# V1\_Drainage Letter\_comments.pdf Markup Summary

## Amo Acres Subdivision

Final Drainage Report

PCD File No: **SF2623**

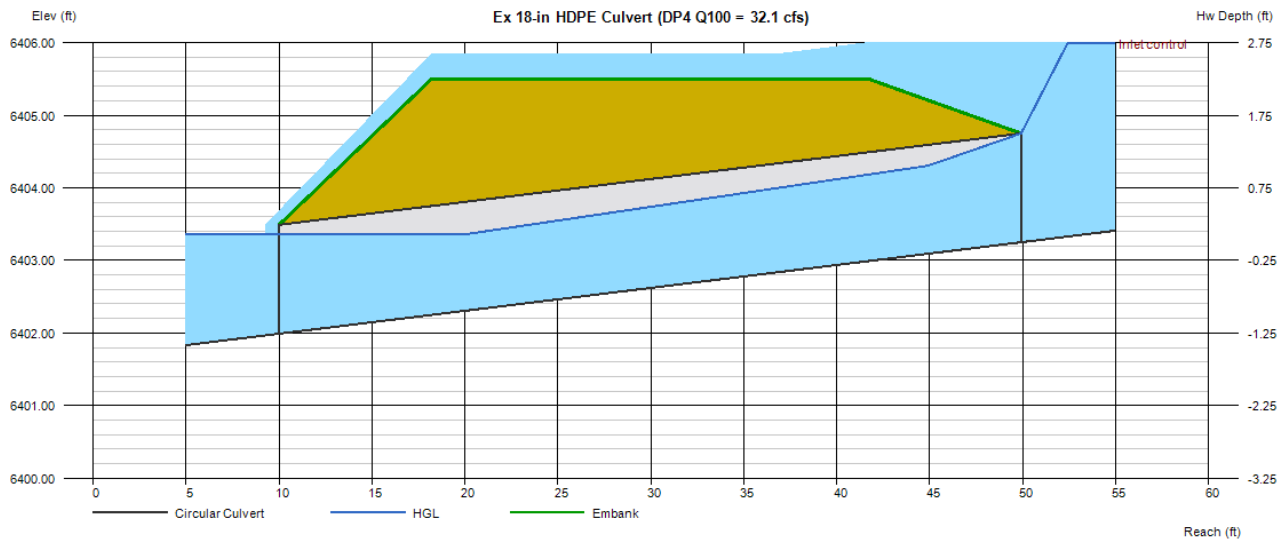
What are you going to do about this over topping?

ATE: Nothing, the over topping condition described herein is a **theoretical** condition. There is no culvert at DP8 currently. Furthermore, per the EPC ECM 3.6.4 overtopping of local roadways is allowed at a depth of 6" when the HW is less than the pipe height.
